### Amendments to the Drawings:

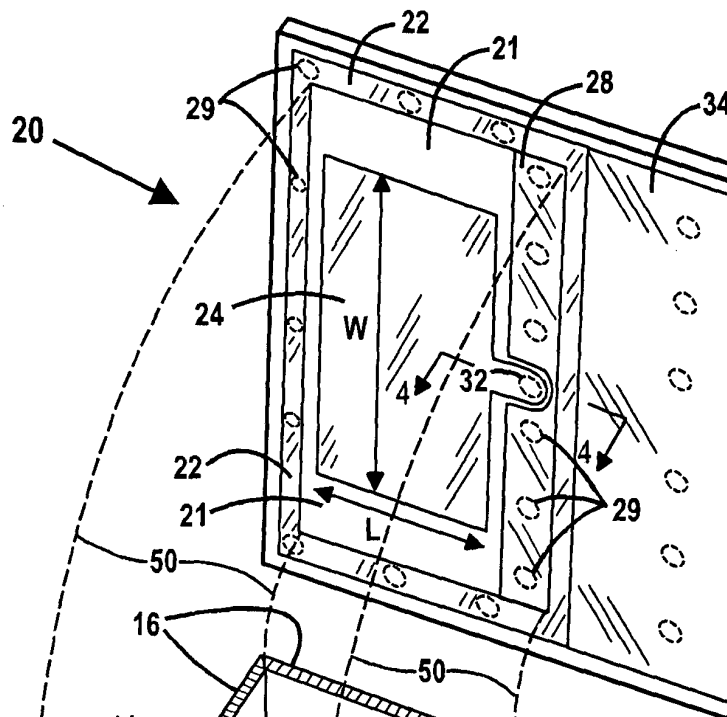
In FIG. 4, previously-omitted ground ring 22 has been added. The original FIG. 4 had show the combination of capacitive diaphragm 28 and ground ring 22 as a single element labeled by reference number 28. The changes to FIGS. 4 correspond FIG. 4 to the perspective view of original FIG. 1, and thus do not enter new matter. The relevant portion of FIG. 1, showing the cross-section plane for FIG. 4, is reproduced below:

The cross-section plane for FIG. 4 is defined in FIG. 2, as originally filed, and corresponds to that shown in the above portion of FIG. 1.
